PRODUCT CHANGE NOTICE

PCN26-012NOTIFICATION DATE: **March 12, 2026****MODELS AFFECTED****HKCA-4011A+**
ADCA4012AMLZ**EXTENT OF CHANGE:**

BEFORE:**AFTER:****EFFECT OF CHANGE:**

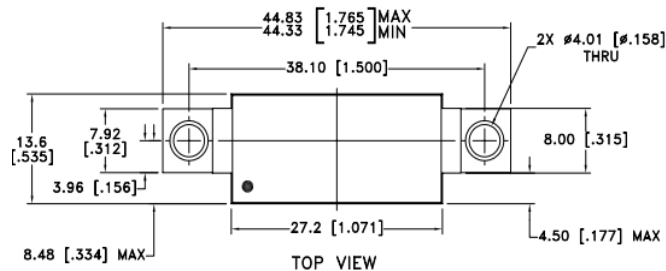
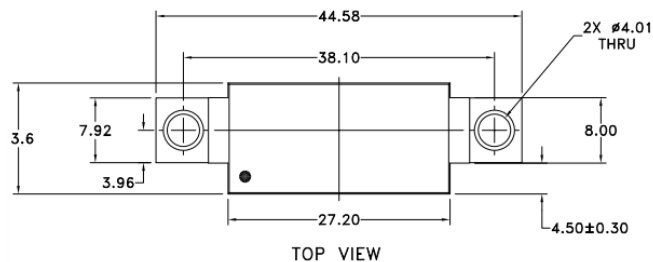
Change of Case Style NP3629-3, removed verbiage max / min and defaulted dimensioning to drawing tolerances.

No change to FORM (Appearance) or FUNCTION (Performance)
FIT (Dimension) specification changed to accurately reflect build tolerances

Change to reduce yield loss from very minor deviations in the casing for the above models. No change to electrical performance.
